BOARD ACTION REPORT – APPEALABLE ITEM

Project Name: Casuarina

Project Location: 1009-1023 Casuarina Road

Application Type: Class V Site Plan, Landscape Plan,
Architectural Elevations– Casuarina Delray Townhomes

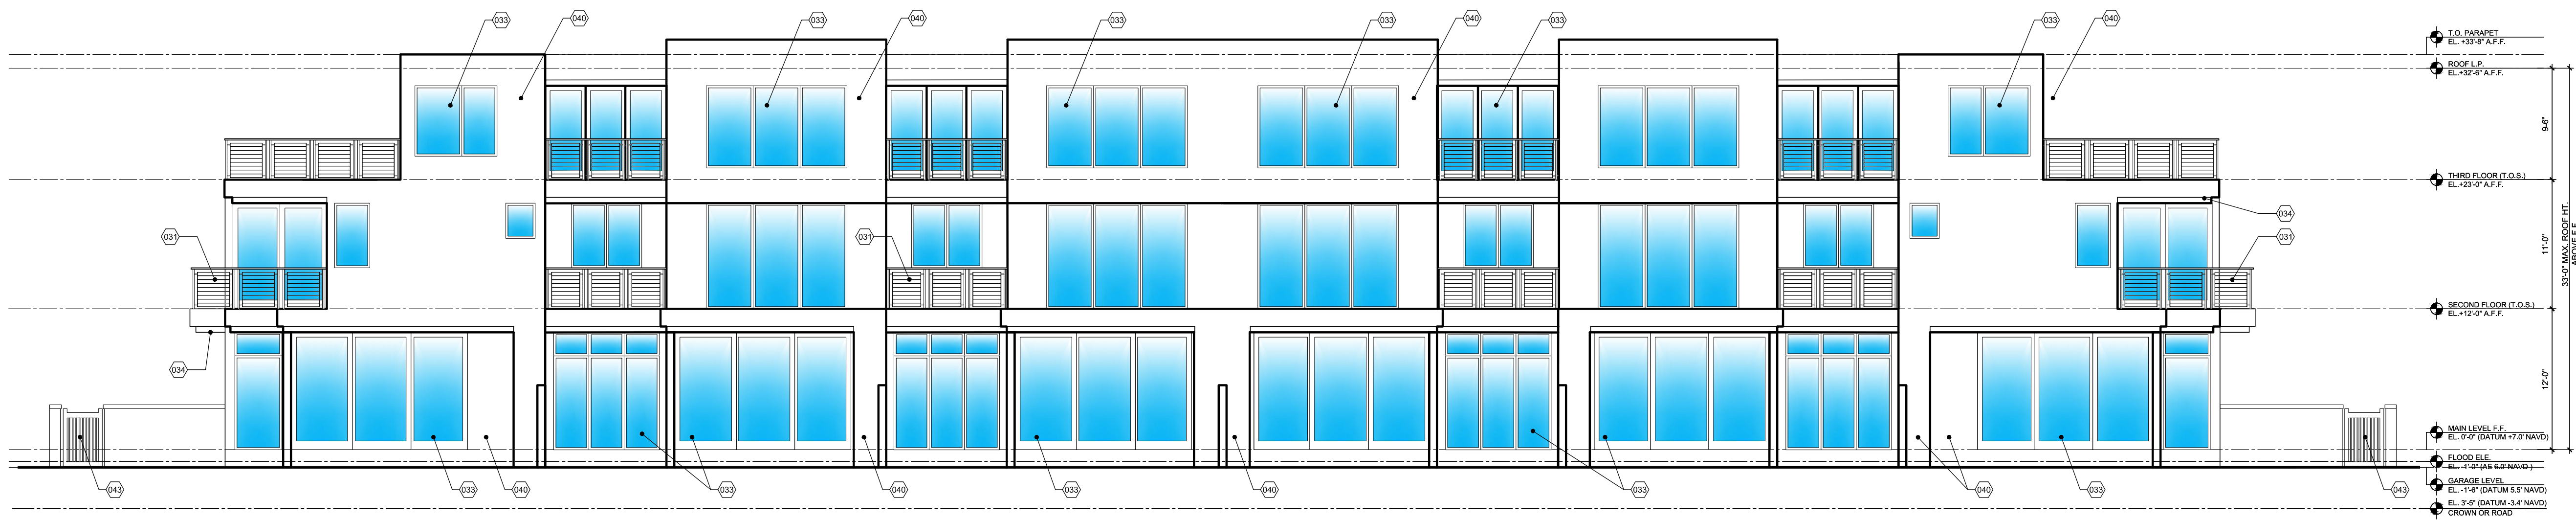
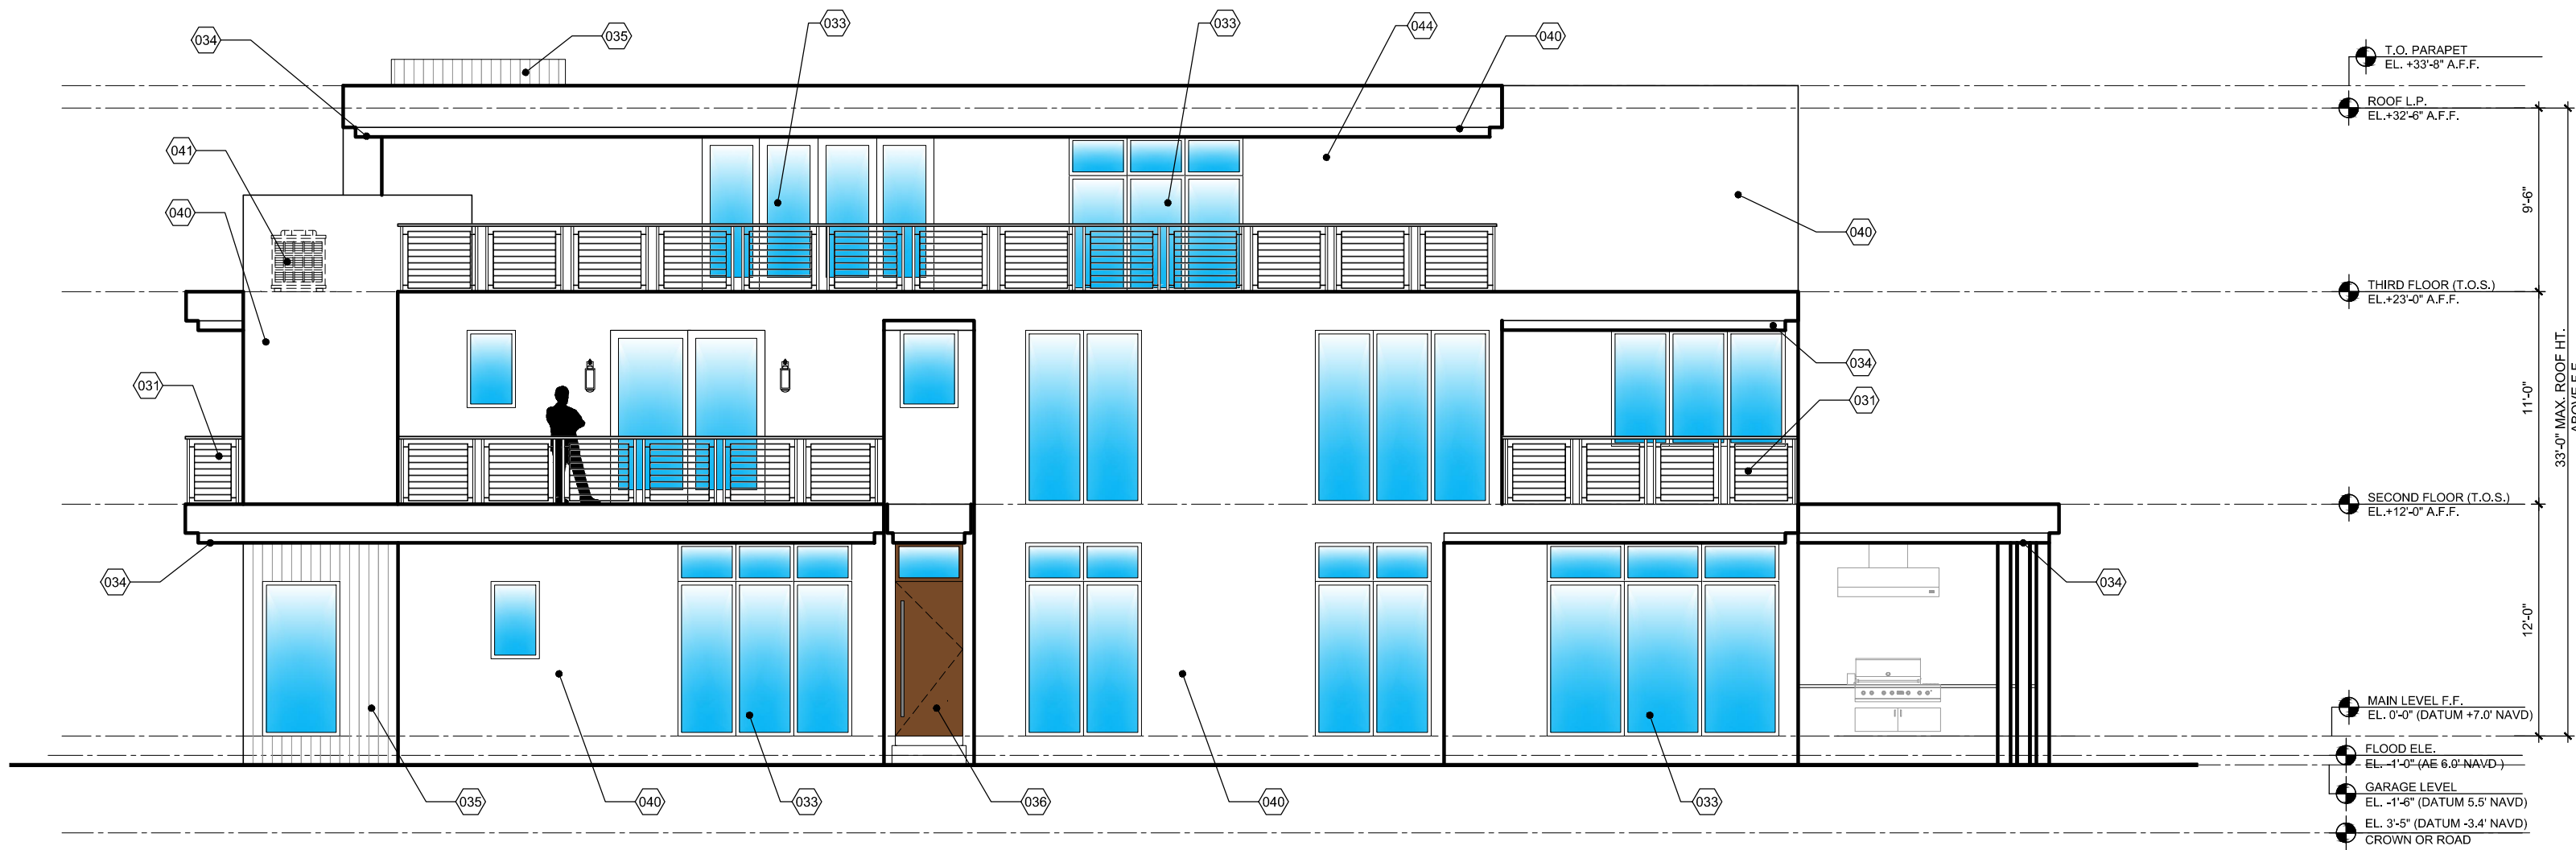
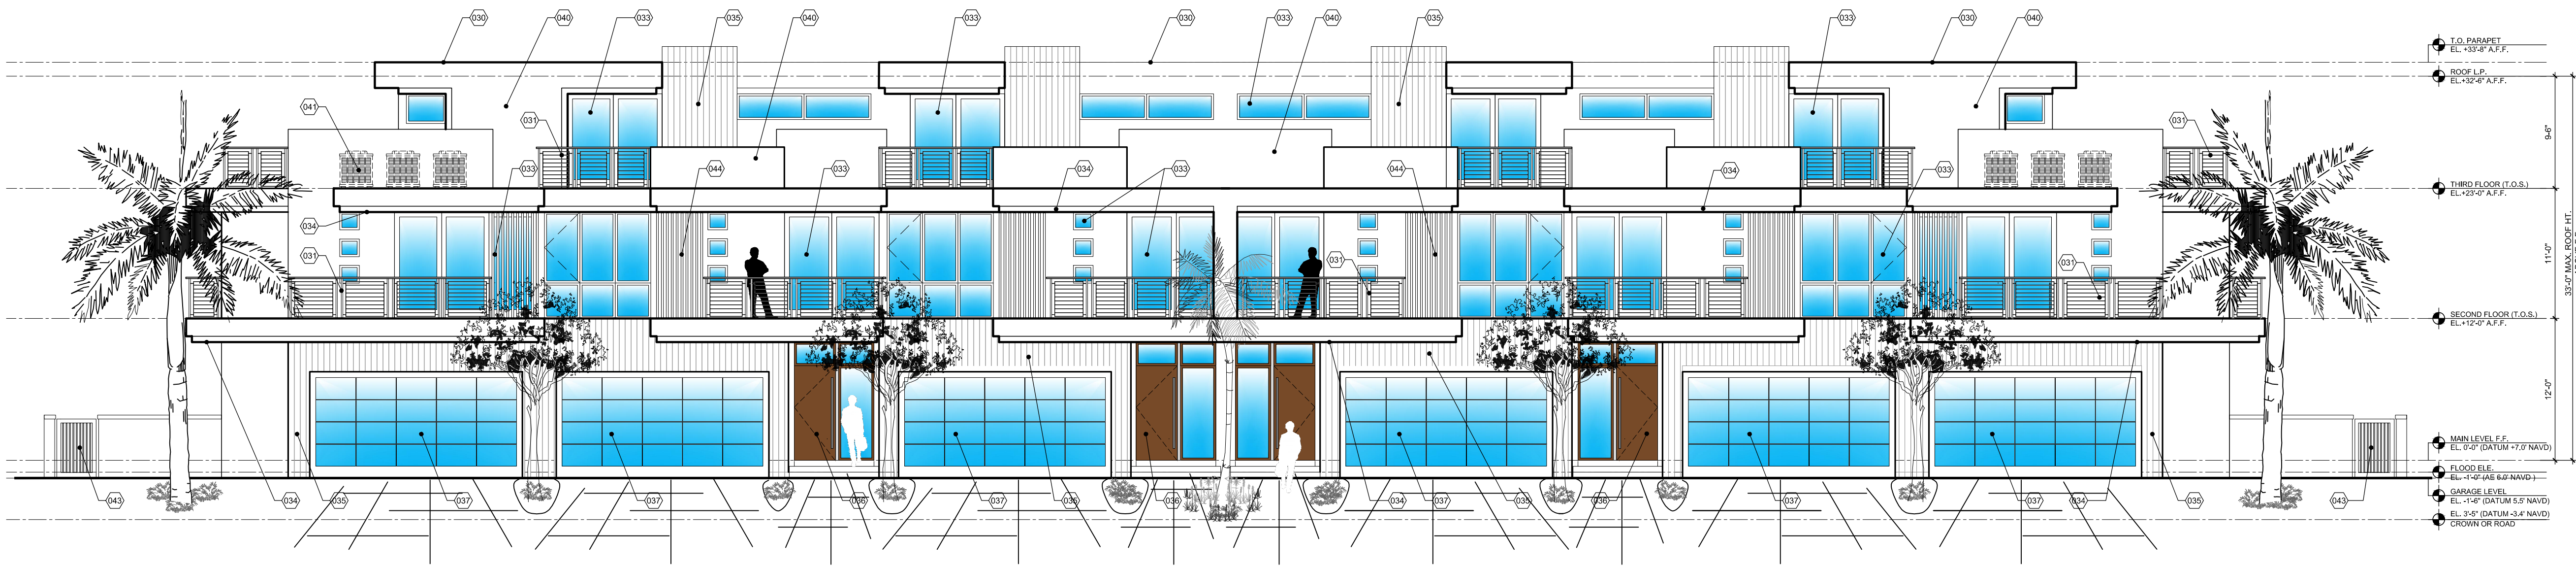
Analysis: **The six unit development has a varied façade that is staggered and offset with a recessed third floor. The architecture consists of flat roofs, impact-rated glass garage doors, wood entry doors, wood cladding, eyebrows and balconies which provide diversity in the framework of the building.**
